Commission Agenda Report

Subject: Coastal Development Permit-Woolsey Fire No. 22-004, Variance No. 22-007 – An application to allow for a conversion of 508-square feet of office/gym space into an attached second unit and a new onsite wastewater treatment system (OWTS); including a variance for development within the required Environmentally Sensitive Habitat Area buffer to allow for the replacement OWTS

Location: 6244 Busch Drive, partially within the appealable zone
APN: 4467-029-021
Owners: Tyler Muir and Bridgette Muir

DATE: 05/20/23	
DESIGNED BY: A. SHIRO	PROJECT NUMBER: NOTED
SCALE: 3/32" = 1'-0"	DRAWING NUMBER: A1

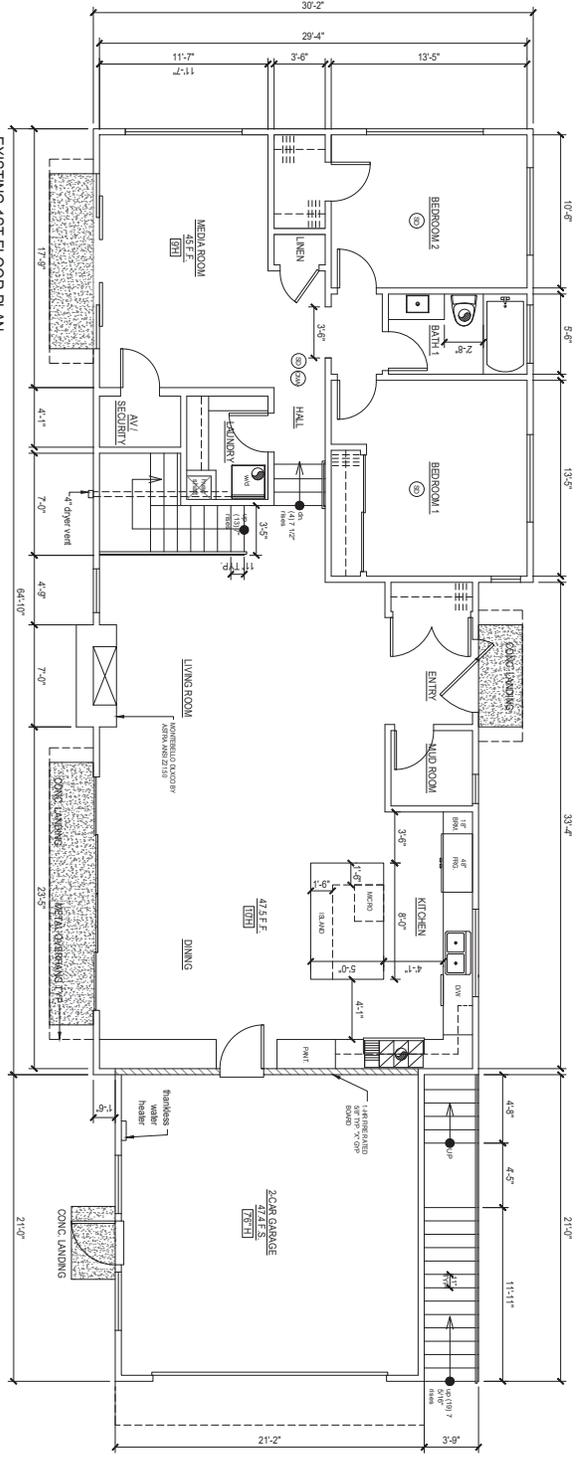
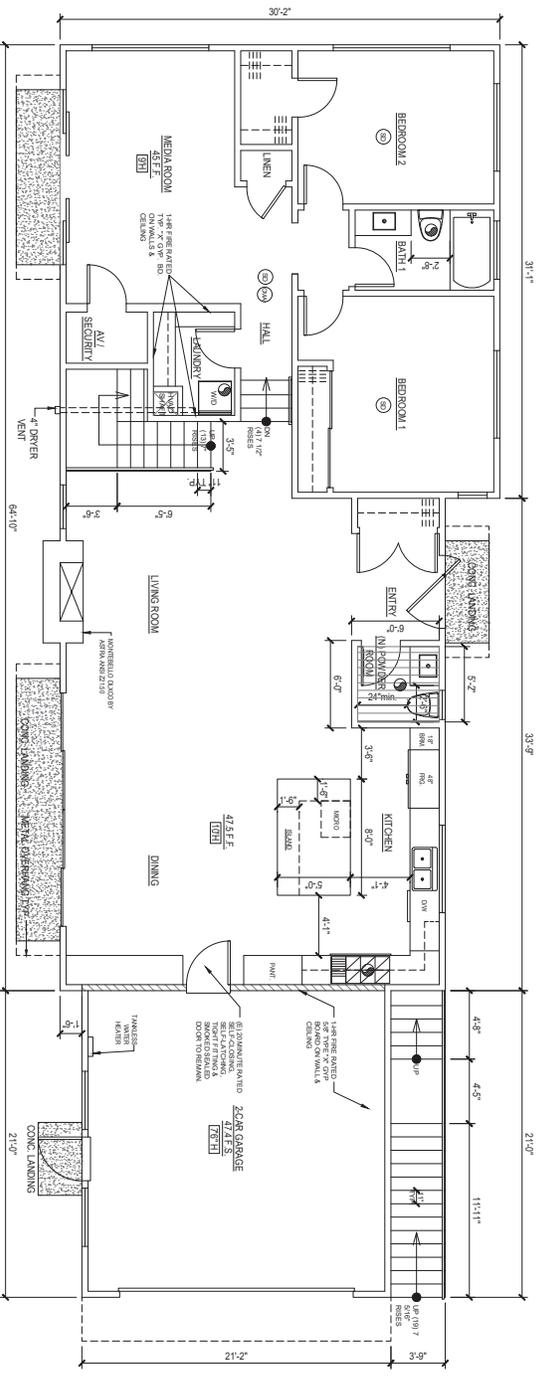
- 1) **OWTS on Architectural Plans:** The final architectural site plan (Sheet A1) must show the proposed onsite wastewater treatment system (OWTS), including the treatment tank, drip dispersal area, and all lines of connection to the residence and ADU.

49. The final architectural plan must show the proposed OWTS, including the treatment tank, drip dispersal area, and all lines of connection to the residence and second unit.
